Design Review Board Study Session

SUBJECT: DR14-33, PADS B AND D AT AZ AVE WINCO

DR14-33, Pads B and D at AZ Ave Winco: site plan, landscape plan, grading and drainage, elevations, floor plans, lighting, colors and materials for approximately 2.0 acres located at the northeast corner of Arizona Avenue and Desert Lane zoned General Commercial (GC) with a Planned Area Development (PAD) overlay.

WEST ELEVATION (PAD D)

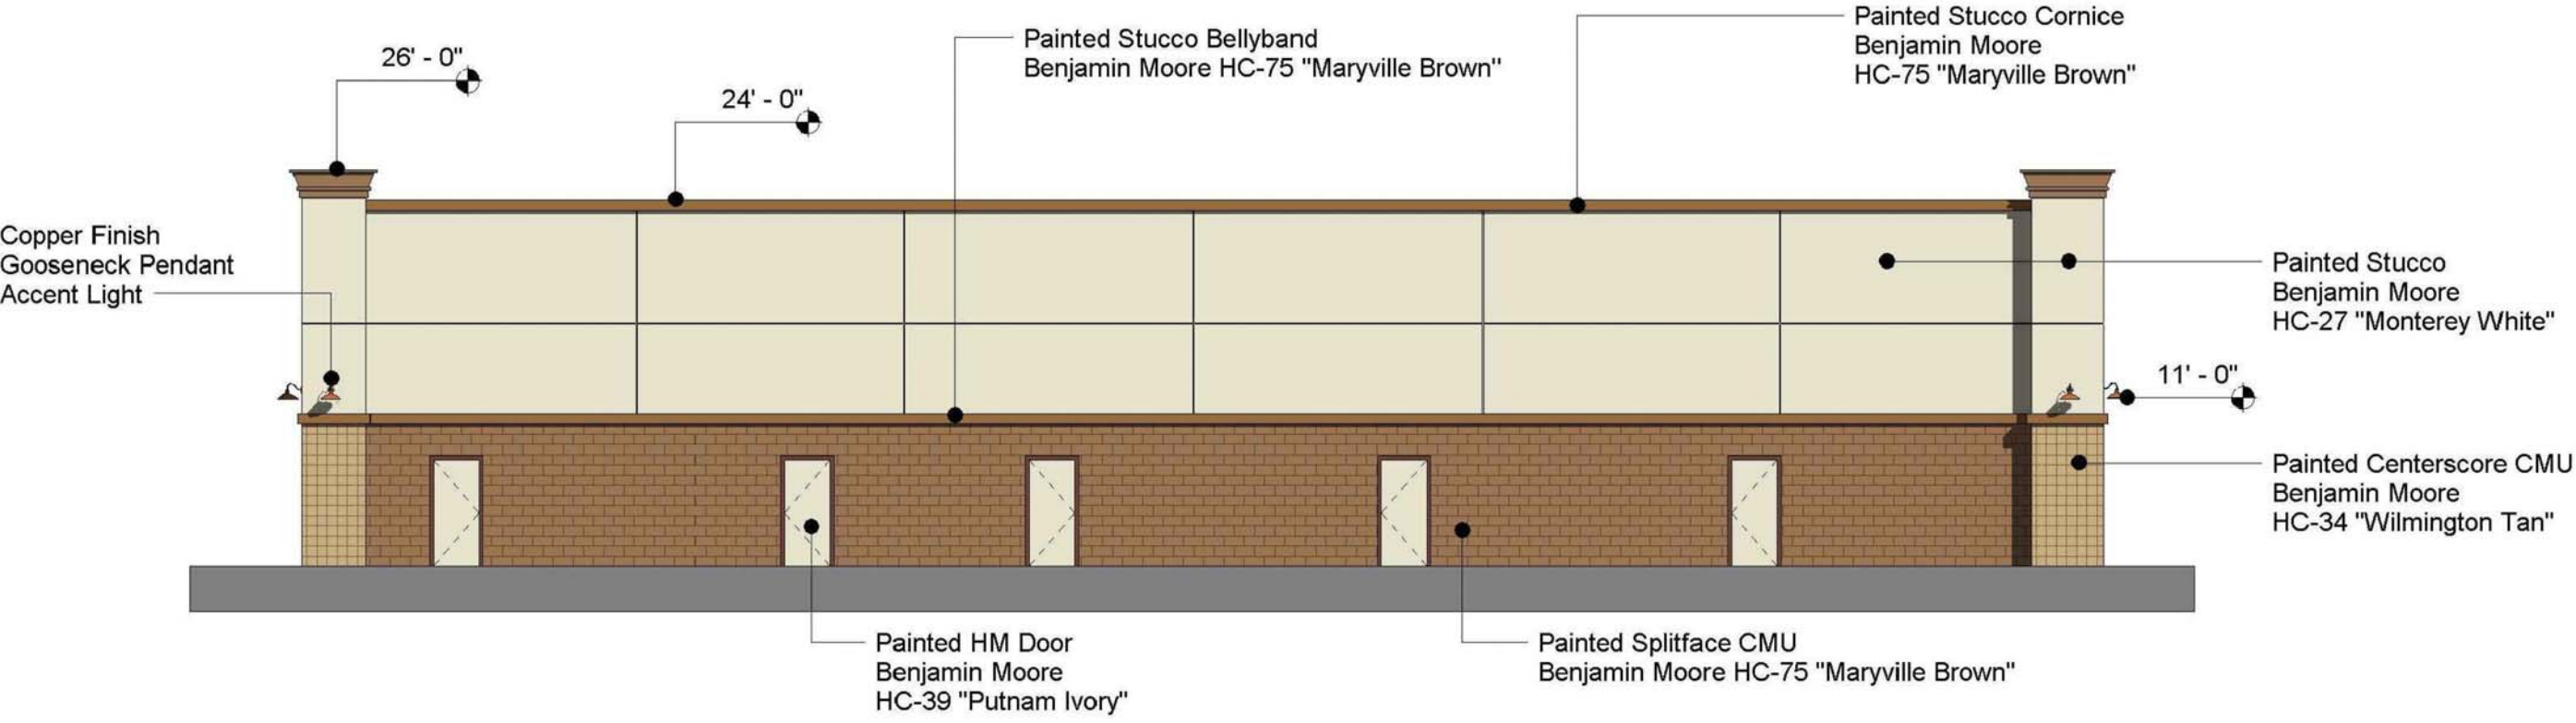
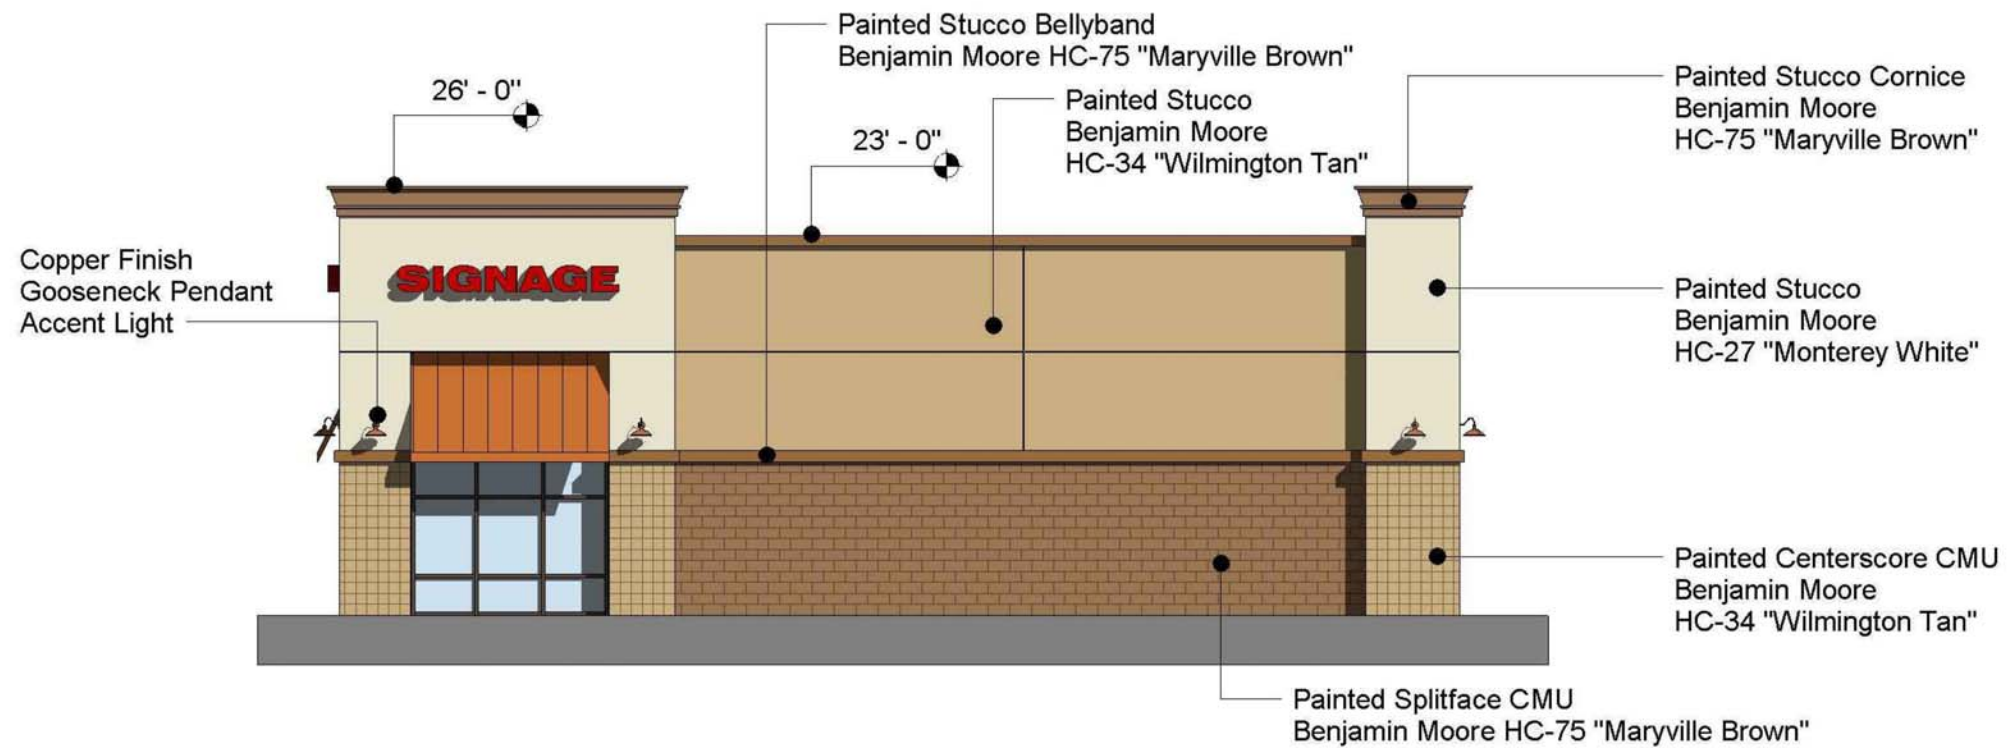
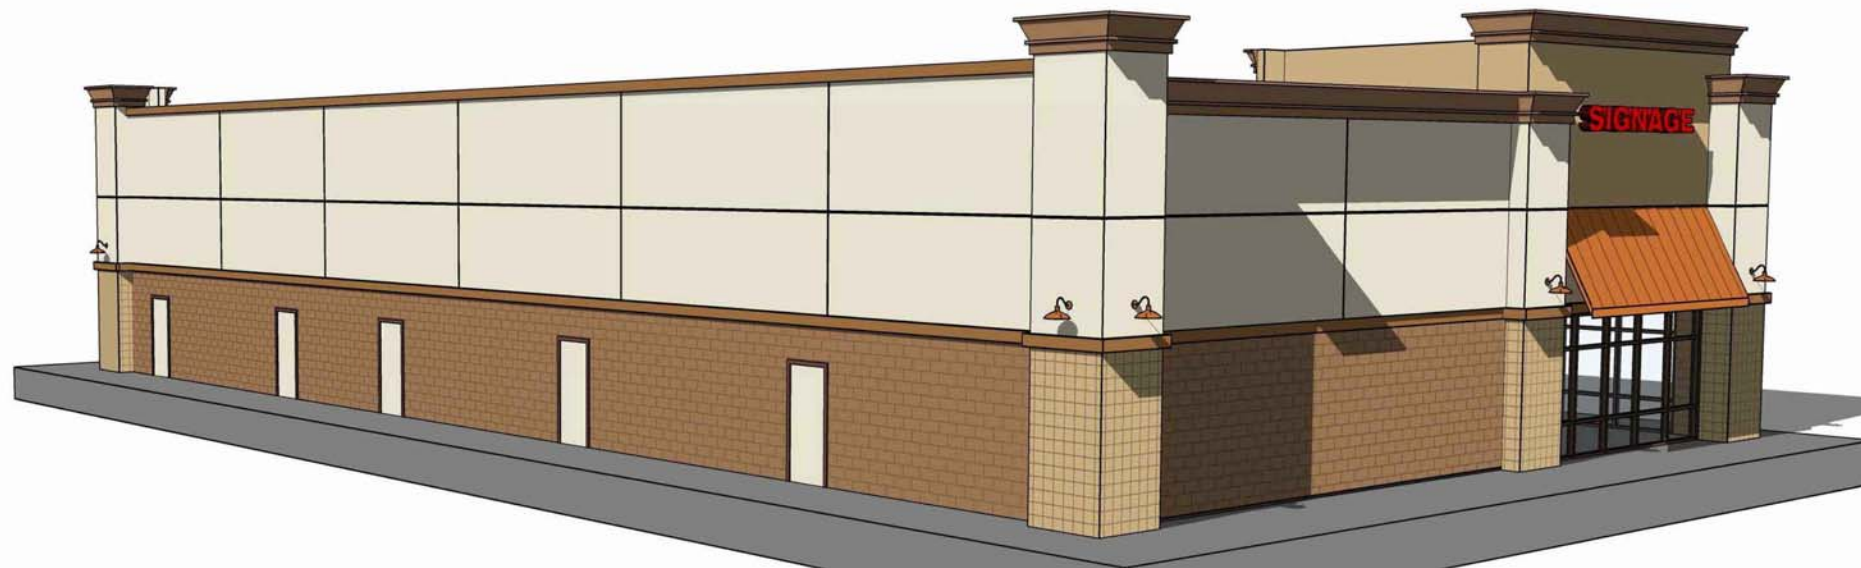
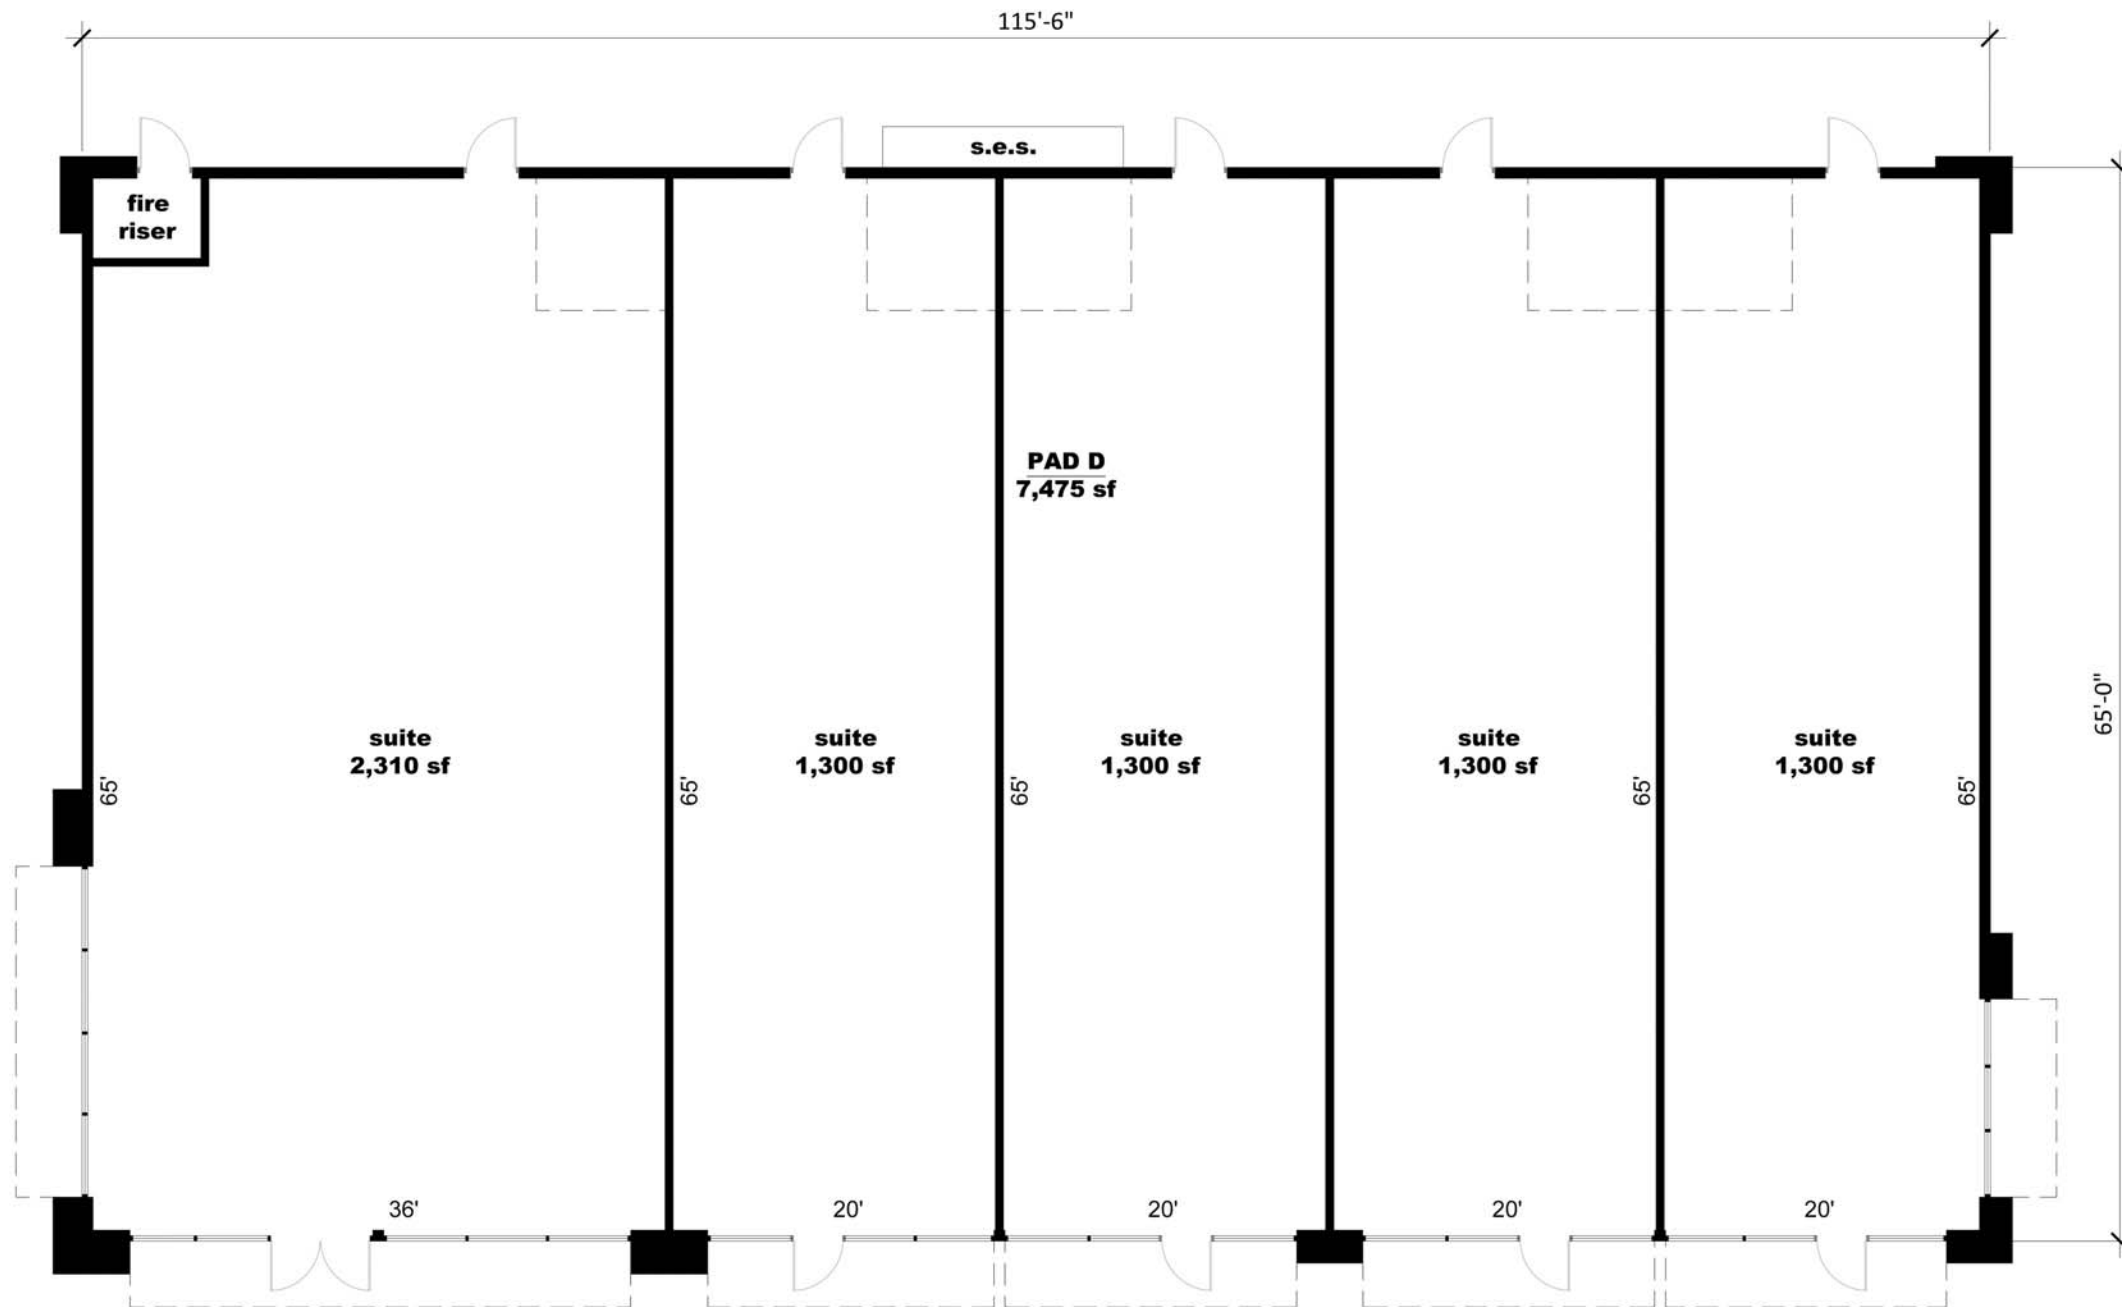
Pad D west, front, elevation has vertical and horizontal movement with the use of two stucco field colors, one CMU block painted block color, accent trim and metal seam copper color awnings. The side elevations, north and south, reflect the front elevation's colors, materials and parapet heights. The rear, east, elevation is screened by the mature vegetation and new landscape, but it is visible within the site and is designed as a 360 degree building. With that being said, staff will request that the rear elevation is enhanced to reflect the colors, materials, vertical and horizontal movement of the front and side elevations. Staff will also request that the service doors be painted Maryville Brown to match the adjacent CMU.
